Port of San Francisco
Joint meeting of the
Port of San Francisco
Waterfront Design Advisory Committee
and
Bay Conservation and Development Commission
Design Advisory Committee

Staff Report

Meeting Date: July 14, 2014 – 5:30PM

Re: **Pier 70 Crane Cove Park Master Plan (“Park Master Plan”)**
(see: sfport.com/cranecovepark)

NOTE:
This site plan reflects "Crane Plaza" Option 2 presented on May 5th, 2014.

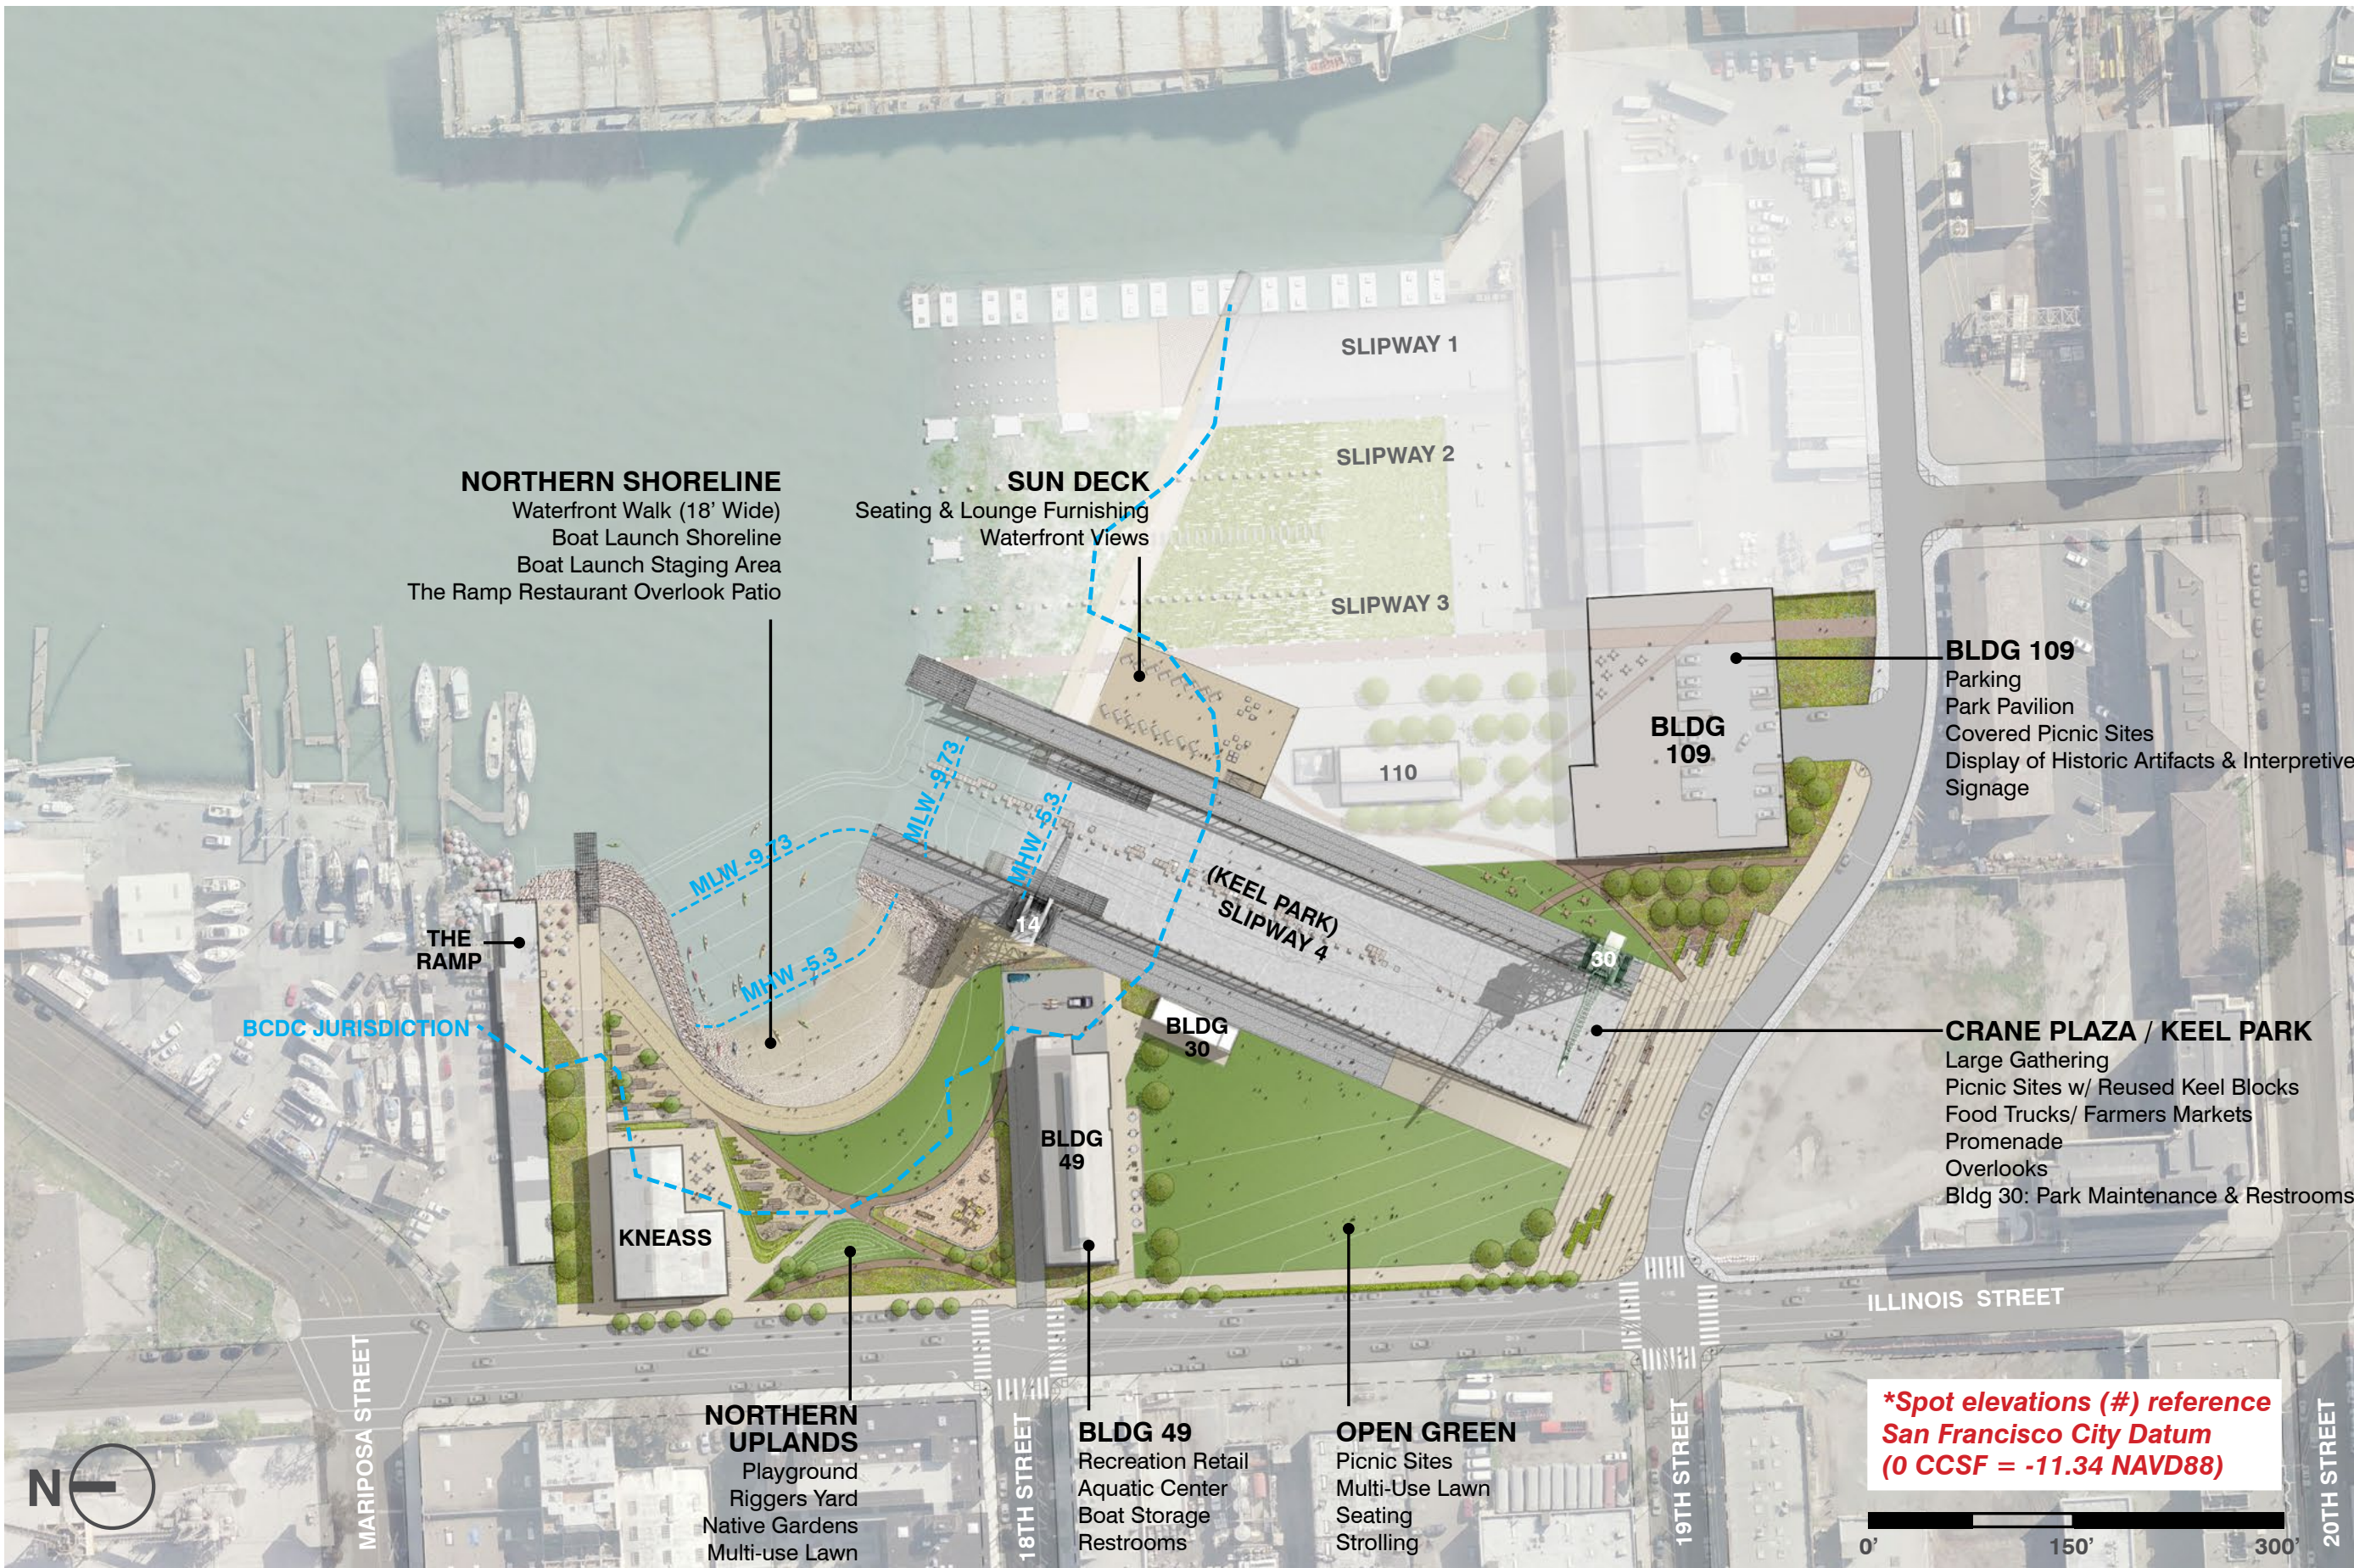
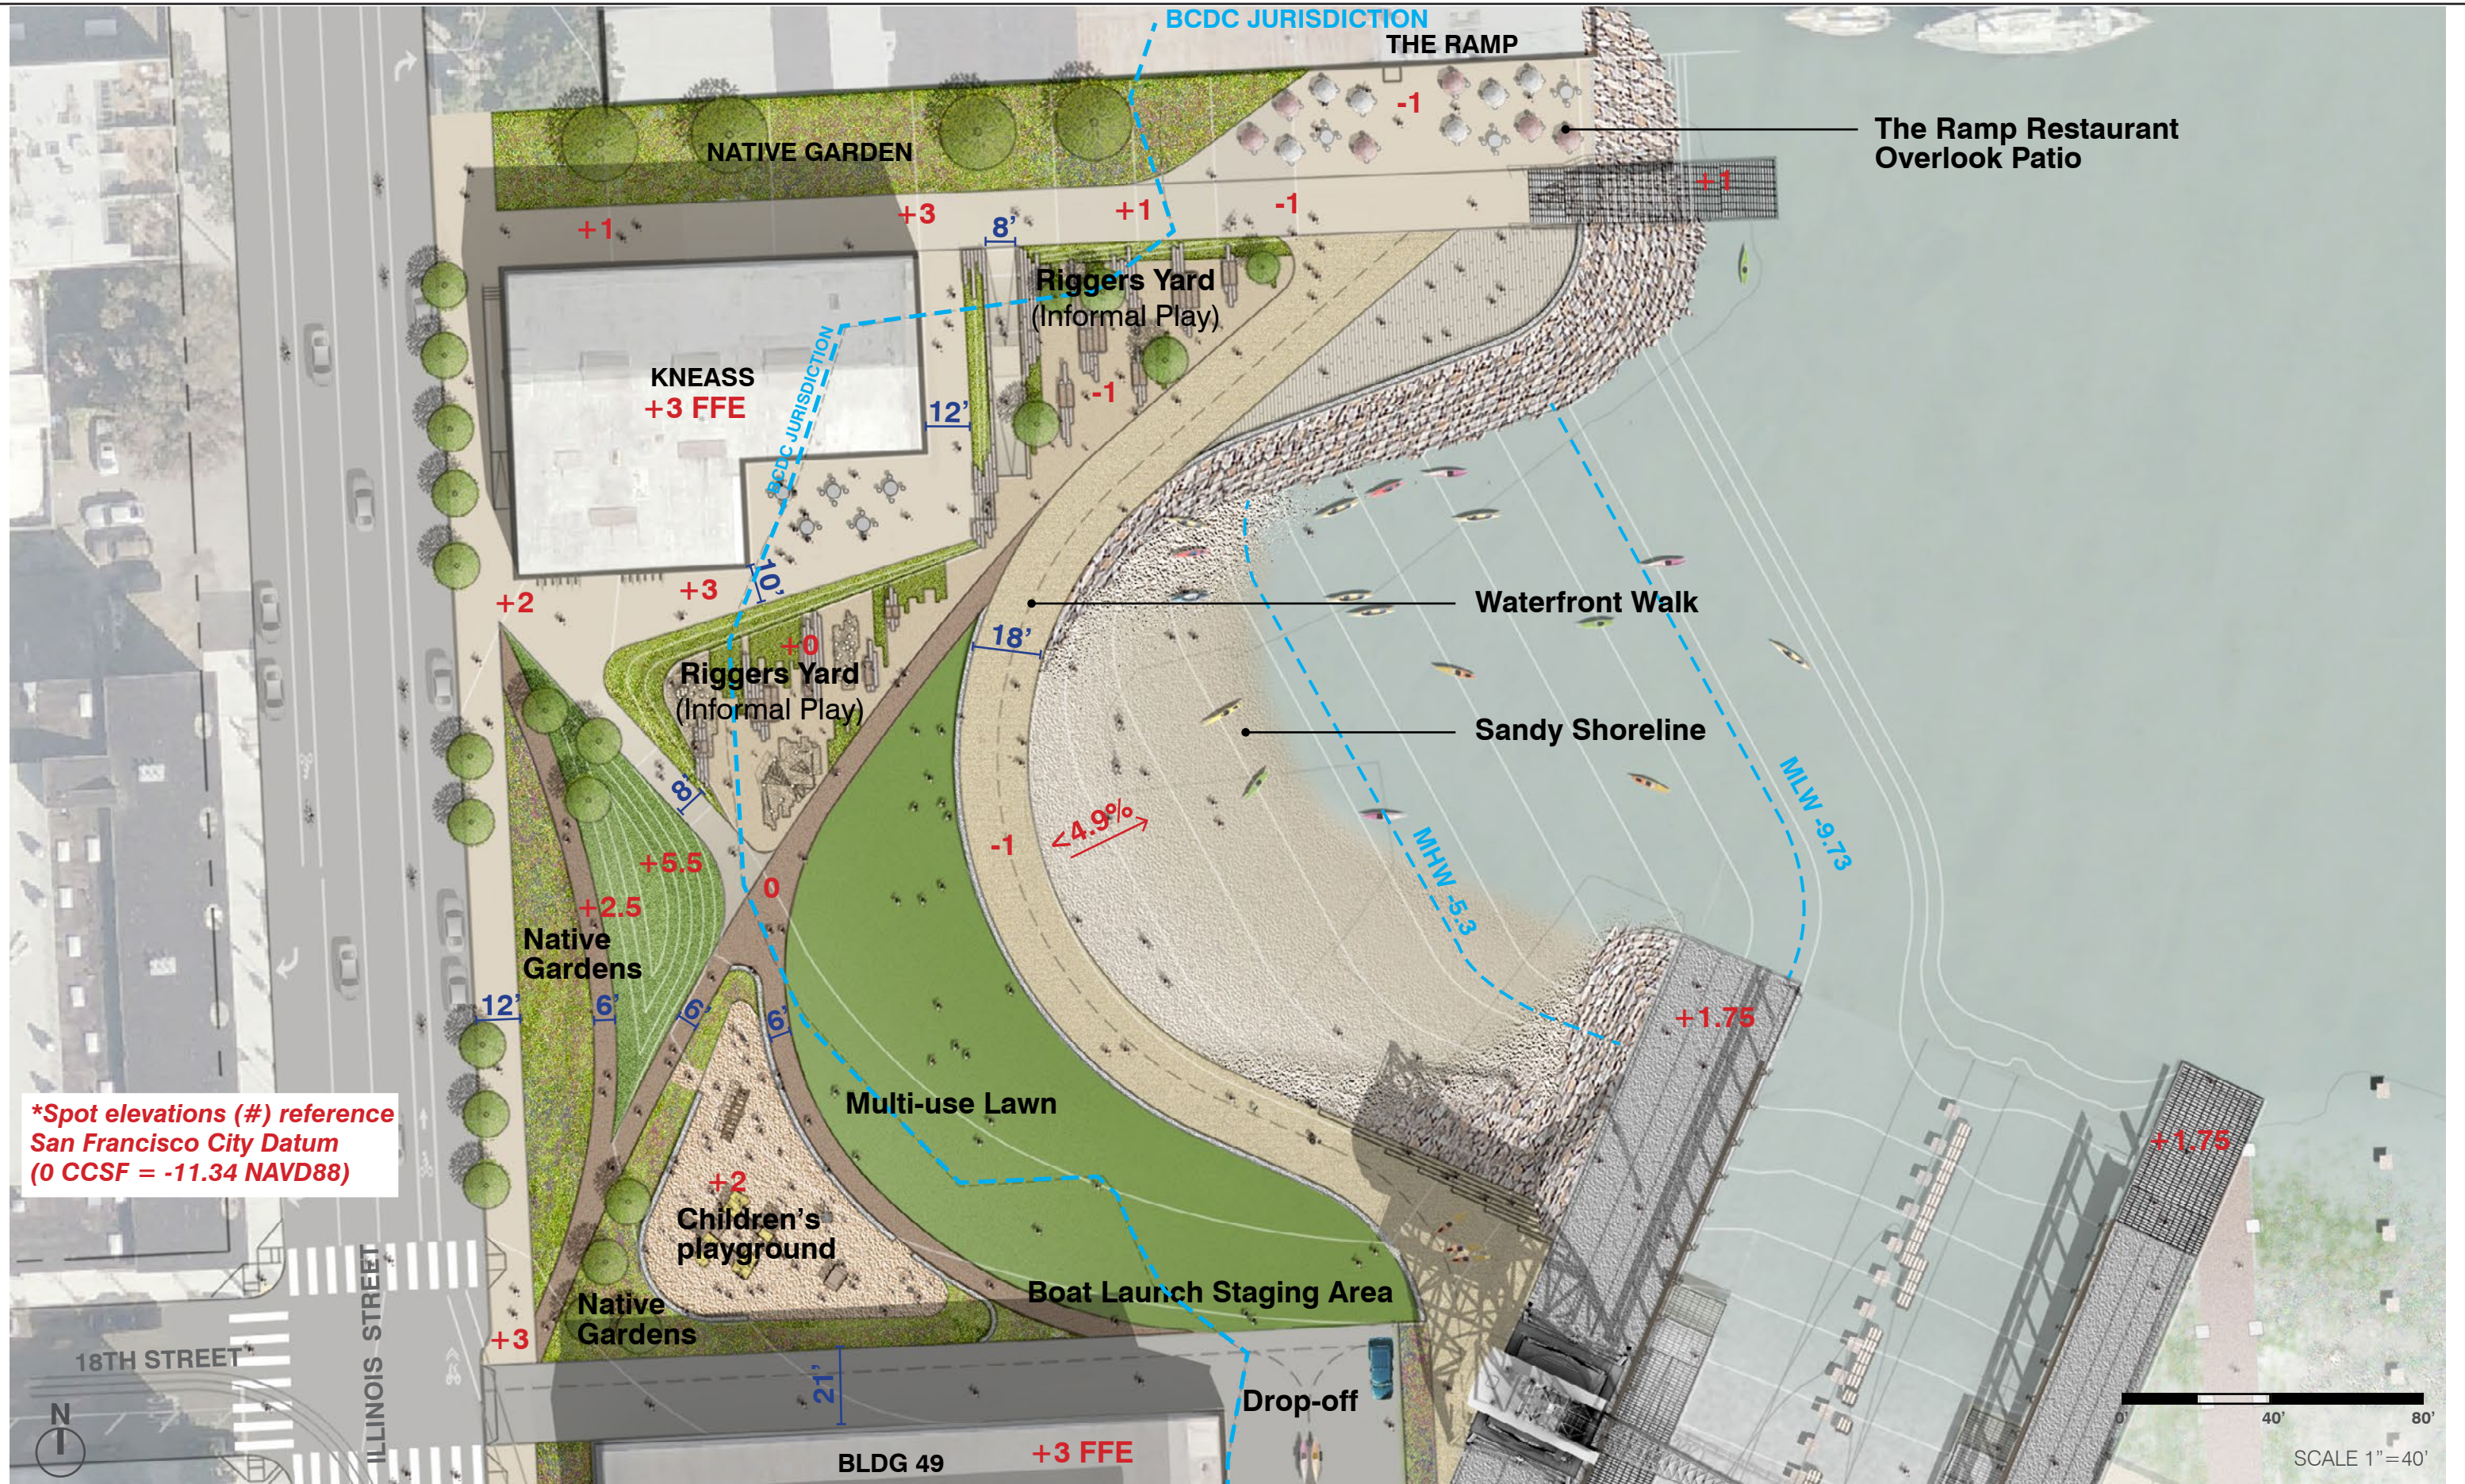
1. Playground area - Expressed concern about how the fenced playground could negatively impact the redevelopment of the Kneass Building because of its close proximity and possible view blockage to the launch and Bay. Expressed concern with how the playground may interfere with the promenade circulation, and requested that other locations and other playground options be explored
2. Expressed concern about the height of the berm adjacent to Illinois Street blocking views into the site
3. Expressed concern about the amount of native garden planting area

1. Requested a design be explored that blends the best attributes of both previous designs presented: universal access into the slipway; and a plaza space that creates a comfortable pedestrian environment for appreciating the Slipway and activities within the Slipway.

In response to the design review meeting, the structured playground area previously located adjacent to the Kneass Building has been moved to an area just north of Building 49 and reduced in size. The current size accommodates toddlers through seven year-olds, which is the age group requiring a more protected space. The structured play area will be designed to reference the ship building artifacts and site history. The area around the Kneass building, now referenced as the Riggers Yard area was simplified and includes an informal play/adventure area not requiring fencing or a defined enclosure. The Riggers Yard area utilizes industrial waterfront forms and structures utilized in ship building to form seating areas and objects that can be used for play or seating. The forms include piles that represent the "ghost piles" that exist near the site and reclaimed slipway cribbage which are 12" x 12" concrete ties of varying lengths between 6'-18' stacked to create benches, retaining walls, beams and other forms that can be played on by older children and adults. The Riggers Yard design revision eliminates the fenced barrier previously considered between the Kneass building and the water's edge and can be passed through and is accessible from most all directions.

The native planting area has been reduced and the path system simplified. A low berm (1-3') between Illinois Street and the multi-use lawn provides a buffer between the busy street and the lawn, provides some enclosure for the area, yet is low enough to maintain views to the site and Bay from Illinois Street.

Exhibits 7 & 8, Crane Plaza Slipway Steps, illustrates a hybrid version of the two concepts, the steps at the terminus of the slipway are terraced and universal access into the Slipway Ways is achieved. The entry area is divided into two spaces: 1) a 15’ wide sloped (<4.9%) walkway to provide access to the terraced steps and Slipway, Ways; and 2) a 31’ wide upper entry space which is flat with an approximate 2% cross slope. The two spaces are divided with a series of seating and retaining walls utilizing the ship building cribbage previously described in the Northern Shoreline area and used in the Riggers Yard. Additionally the park entry area is flanked with seating and retaining walls with planters also utilizing the form of the ship building cribbage. Providing universal access into the Slipway Ways also accommodates vehicular access into the Slipway Ways for loading and unloading to support special events and other programming.

The material for this area is concrete with a distinct concrete color and finish from that of the historic slipway and use of cobble paving band along the south edge of the seating steps to serve as a transition between the entry and the seating steps.
